PREDETERMINATION SETTLEMENT AGREEMENT

CP# 01-19-73073
HUD# 07-19-0948-8

covered unit.”¹ Complainant specifically alleged, in Units 502, 504, 522, and 523, 1501 State Street, The Bridges Lofts (“Bridges”), four features in the common areas and three features within two of the covered units appeared inaccessible to a person utilizing a wheelchair for mobility, as listed below:

EGRESS DOOR OPENING FORCE:
INTERIOR SWINGING DOORS 5 LBS⁶

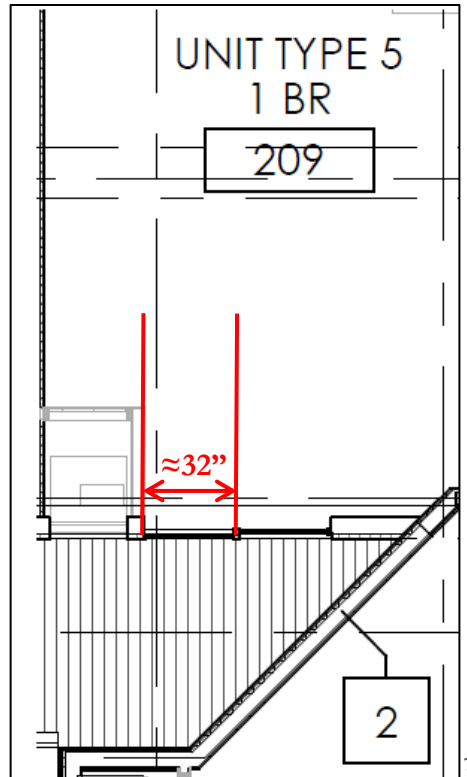
2) The construction plans submitted by Respondents include instructions on sheet G102 for setting the maximum force level required to open interior doors, as shown in the following excerpt:

The force required to open the doors to the Community Room and the women’s bathroom exceeded the 5-pound maximum limit allowed by ANSI 1986 for interior-hinged doors. If the self-closers in these doors would have been set according to the instructions in the construction plans, these doors would have been compliant with the 5-lb. maximum force requirement from ANSI 1986. However, as installed, these doors require too much force to open, which makes them unusable for persons with disabilities who have diminished strength to push or pull.

- 2) Respondents will adjust the self-closers of the doors to the Community Room and the Women's bathroom to comply with the 5 lbs.-maximum required by ANSI – and which will be completed no later than July 31, 2019.

- 2) ICRC agrees with Respondents' proposal to adjust the self-closers of the doors to the Community Room and the Women's bathroom to comply with the 5 lbs.-maximum required by ANSI – and which will be completed no later than July 31, 2019.

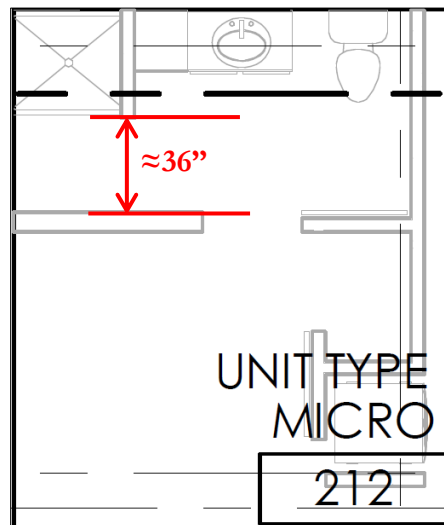
3) The construction plans submitted by Respondents include scaled diagrams for the clear opening width of the sliding glass doorway in Unit 209, as shown in the following captioned screenshot:

The sliding glass doorway in Unit 209 would have been compliant with the 31 $\frac{5}{8}$ "-minimum clear opening width requirement if installed according to the plans. But, as built, it is too narrow, rendering it unusable by persons using wheelchairs.⁸

- 3) Respondents will (i) adjust the clear opening width of the sliding glass doorway in Unit 209 to comply with the 31 5/8"-minimum width required in the Manual; (ii) inspect the remaining 11 5-1, and if found to be narrower than the 31 5/8"-minimum width required, complete the same retrofit as for Unit 209; and (iii) complete this retrofit no later than July 31, 2019.

- 3) ICRC concurs with Respondents' proposal to (i) adjust the clear opening width of the sliding glass doorway in Unit 209 to comply with the 31 ⁵/₈"-minimum required in the Manual; (ii) inspect the remaining 11 5-1, and if found to be too narrow, complete the same retrofit as for Unit 2019; and (iii) complete this retrofit no later than July 31, 2019.

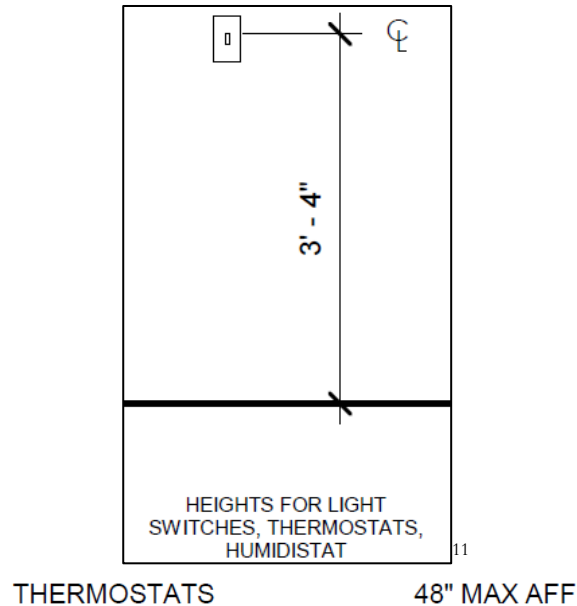
4) The plans submitted by Respondents include scaled drawings of the dwelling units. The relevant portion of the drawing for Unit 212 [0M] is shown at the top of the next page:⁹

Based on the scaled drawing above, the route to the shower stall area from the bathroom sink in Unit 212 was designed to be about 36" wide. ICRC Investigators measured this route at 28 5/8" wide.¹⁰

As built, this route is too narrow because the measured width is less than the 32"-minimum width required for routes that measure less than 24" long, which renders this route inaccessible for tenants who use wheelchairs.

- 4) Respondents will (i) widen the clear width of the path from the sink to the shower stall in the bathroom of Unit 212 to bring it into compliance with the 32"-minimum clear width required; (ii) inspect the two other 0M units and complete the same modification if this path is narrower than the 32"-minimum width required; and (iii) complete this retrofit no later than December 31, 2019.

- 4) ICRC agrees with Respondents proposal to (i) widen the clear width of the path from the sink to the shower stall in the bathroom of Unit 212 to bring it into compliance with the 32"-minimum clear width required; (ii) inspect the two other 0M units and complete the same modification if this path is narrower than the 32"-minimum width required; and (iii) complete this retrofit no later than December 31, 2019. ICRC will require all retrofits required within the dwelling units to be completed sooner if requested by a tenant with a disability.

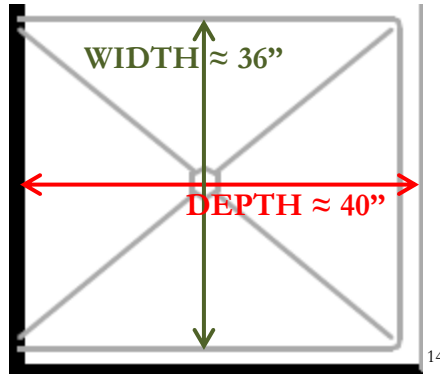
5) The construction plans submitted by Respondents indicate thermostats were to be installed at either 40" or 48" above the finished floor, as indicated in the following drawing and instructions:

If the thermostats had been installed according to the construction plans, the height of the thermostats would have been compliant with the 48"-maximum height requirement. However, the height of the top control buttons of the thermostats in Units 209 [5-1] and 210 [0M] was measured at no less than 50 1/4", which exceeds the 48"-maximum height.¹² The thermostats in these units are too high, rendering them unusable by persons using wheelchairs.

- 5) Respondents will (i) remount the thermostats in Units 209 [5-1] and 210 [0M] at heights not exceeding the 48"-maximum height required by the Manual and as measured to the top control buttons; (ii) inspect the other 5-1 and 1M units and complete the same modification if the thermostats are at heights exceeding the 48"-maximum; (iii) complete these retrofits no later than July 31, 2019.

- 5) ICRC concurs with Respondents' proposal to (i) remount the thermostats in Units 209 [5-1] and 210 [0M] at heights not exceeding the 48"-maximum height required by the Manual and as measured to the top control buttons; (ii) inspect the other 5-1 and 1M units and complete the same modification if the thermostats are at heights exceeding the 48"-maximum; (iii) complete these retrofits no later than July 31, 2019.

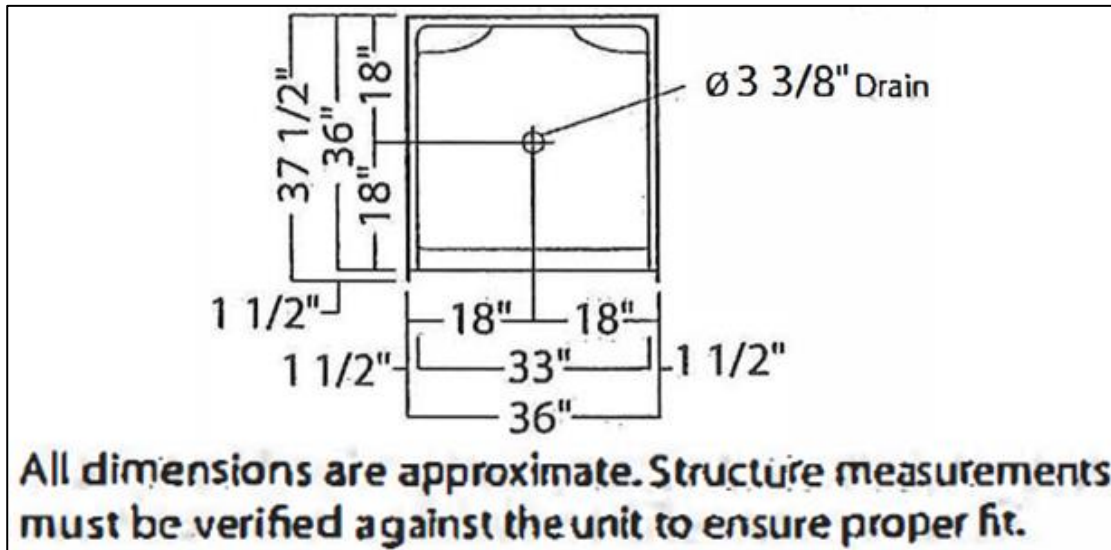
Based on this scaled drawing, the interior usable space of the shower stalls was designed to be about 36” wide by about 40”. However, Respondents also submitted a copy of the “Technical Specifications” sheet from the manufacturer of the shower stalls, which they indicated is typical of the stalls they installed in these units. This product sheet includes a drawing that indicates the dimensions of the shower, and guidance on how to interpret the measurements indicated in the drawing, both of which are shown below:

As indicated in the drawing above, the width of the interior space is designed to be 33”. As designed and built, the interior space of the shower stall in these units is less than the 35 1/2” by 35 1/2”-minimum required, which render these shower stalls unusable by persons who use a wheelchair.

- 6) Respondents acknowledge the minimum size of shower stalls that are the only bathing facility in a dwelling unit is 35 1/2" x 35 1/2" – which is a “nominal” 36” by 36” that is required in the Manual. However, Respondents maintain they did not realize the shower stalls selected to be installed at the subject property did not meet the minimum dimensional requirements because the definition of this standard in the Manual is ambiguous – (i) the Manual does not clearly state the specific linear dimension meant by a “nominal” 36” by 36”; and (ii) this requirement is only specifically defined in a HUD training manual instead of the Manual. Additionally, Respondents maintain the industry definitions of “nominal” minimum shower sizes indicated to them at the time they designed and built the subject property that they were in compliance with the accessibility requirement from the ICRA and FHA.

- 6) ICRC concurs with Respondents' acknowledgement that the minimum size of shower stalls – when they are the only bathing facility in a dwelling unit – is a “nominal” 36” by 36” (i.e., 35 ½” by 35 ½”) – which is required in the Manual. ICRC also agrees Respondents did not realize the shower stalls selected to
